Re: Benthic Impairment TMDL Development for the Roanoke River (Draft)

Responses to Letters Dated September 16, 2005 and November 3, 2005

Benthic TMDL Report Comments

Exhibit 1 – TSS in Roanoke River at USGS 02055000 versus River Flow Rate

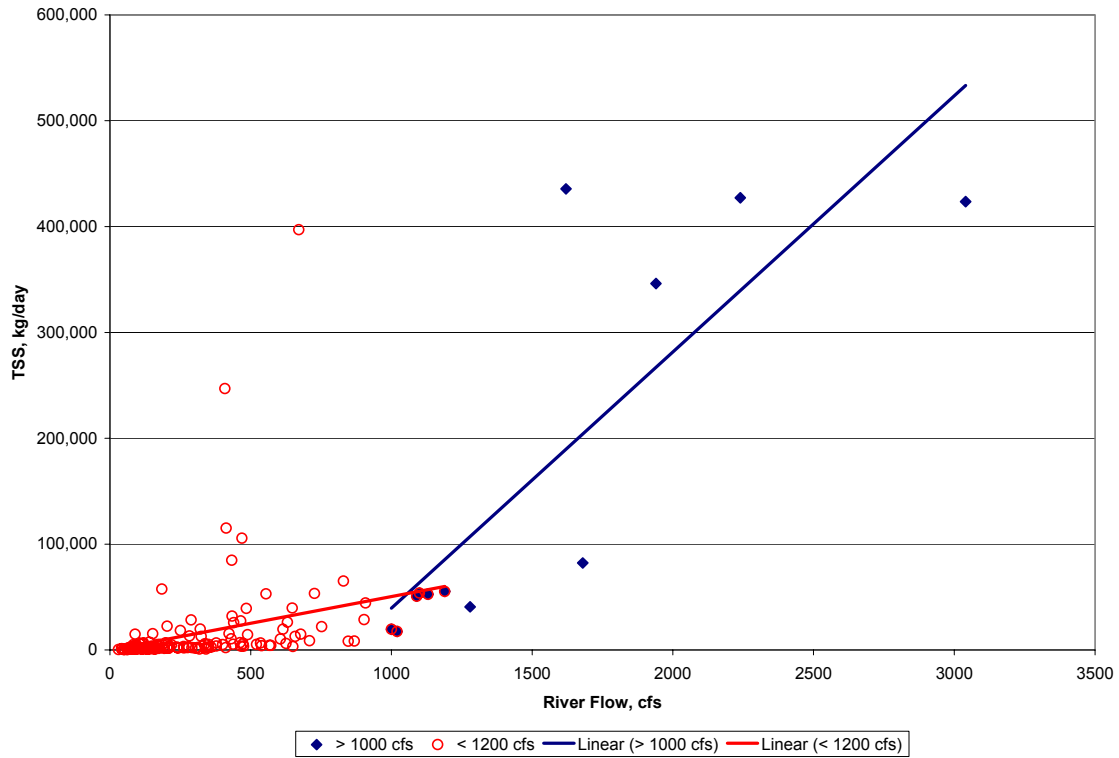
The amount of TSS contained in the river flow is an indication of the amount of material that remains in suspension in the river flow after a significant portion of sediment may have settled along the river bottom. A comparison between the amount of TSS in the Roanoke River at USGS 02055000 for the period January 1990 thru November 2004 and the flow in the river is provided in Exhibit 1³. As can be seen from this exhibit, the amount of TSS in the river during periods of flows greater than 1000 cfs is substantially greater than during periods of flow of less than 1000 cfs.

Exhibit 2: WWA WPCP Flow as a function of Flow in Roanoke River at Roanoke

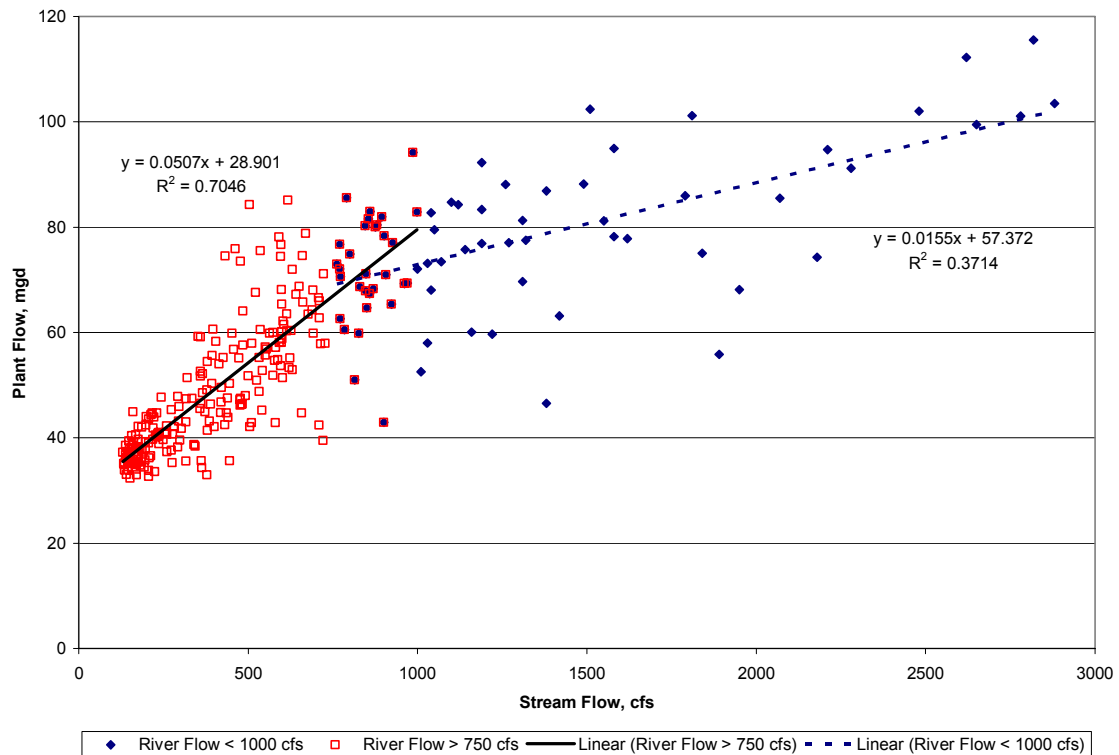
The flows at the Regional WPC Plant for the period of May-July 2003 were compared to the flow in the Roanoke River at USGS 02055000⁴ in order to investigate the relationship between river flows and flows at the treatment facility. These data are presented in Exhibit 2. As can be seen from this exhibit, the periods of high flow at the facility coincide with periods of high flow in the Roanoke River (>1000 cfs). As a result, an increase in the discharge of TSS from the Regional WPC Plant during periods of rain-induced flows entering the facility would be insignificant when compared to the TSS in the river during the same periods.
